HADITHA GENERAL HOSPITAL
UNDER THE ECONOMIC SUPPORT FUND PROGRAM
HADITHA, IRAQ

SIGIR PA-08-132
JANUARY 23, 2009

SUBJECT: Report on Project Assessment of the Haditha General Hospital, Haditha, Iraq
(SIGIR Report Number PA-08-132)

Figure 3. Preliminary floor plan of the new surgery wing addition

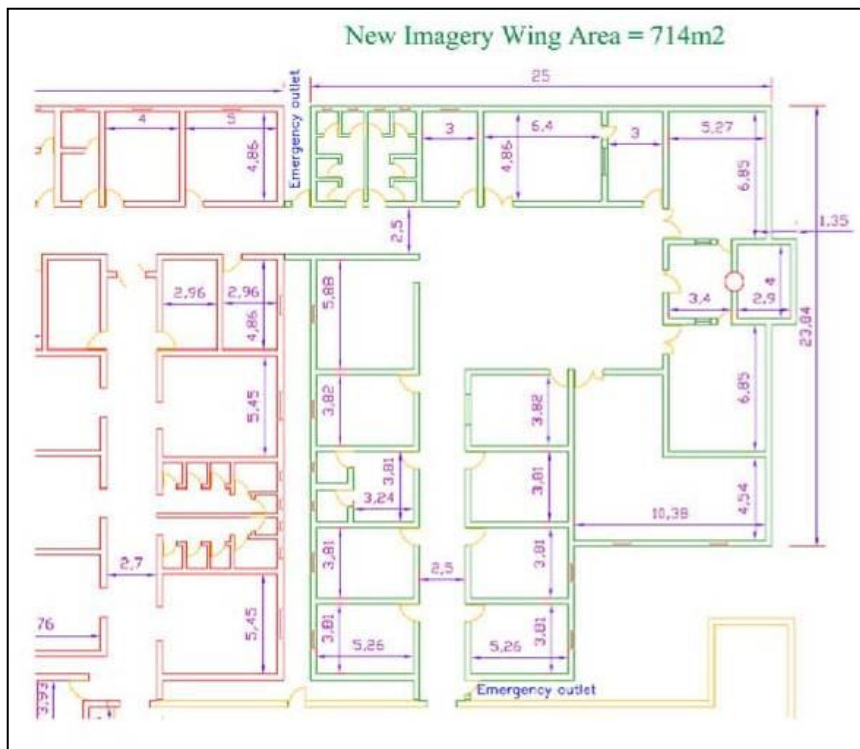
On 29 May 2008, the contractor submitted the revised proposal for the renovation and additions to the Haditha General Hospital project. The contractor included several preliminary floor plans for the proposed additions (Figures 3 and 4). The contract's BOQ provided enough information and detail for the contractor to renovate the hospital without detailed designs.
